**TRUCK UTILITY LT GS SERIES 3 LANDROVER, ALL TYPES**  
**REMOVAL OF STARTER MOTOR**  
**MODIFICATION INSTRUCTION**

**FIG 1 - POSITION OF HOLE**  
**E N D**

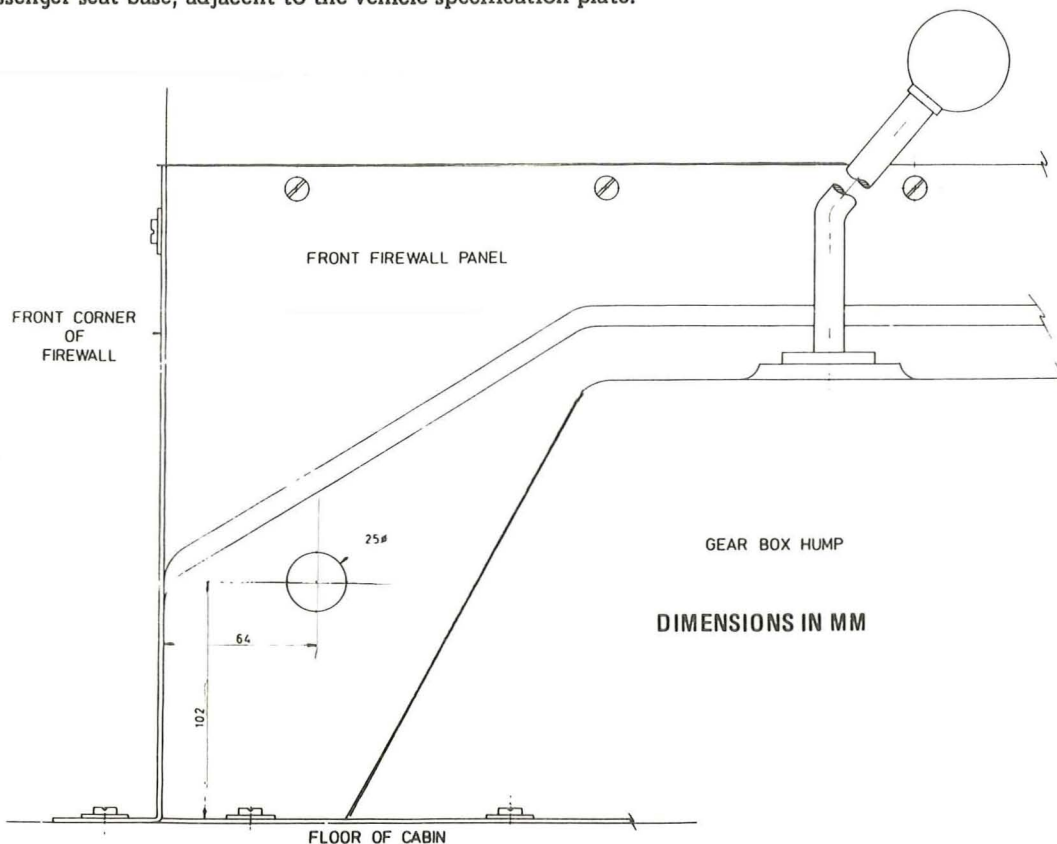
7. Modification procedure is as follows:
  - a. Remove the front firewall panel.
  - b. Drill a 25 mm hole in the front firewall panel as shown in Fig 1.
  - c. Plug the hole in the front firewall panel using a suitable grommet from the GJ Automotive Grab Kit, series No 90.
  - d. Bend the clutch slave cylinder hydraulic pipe and reroute the reversing light switch wiring loom to permit direct access to the starter motor top mounting nut with a socket and bar.
  - e. Refit the front firewall panel.
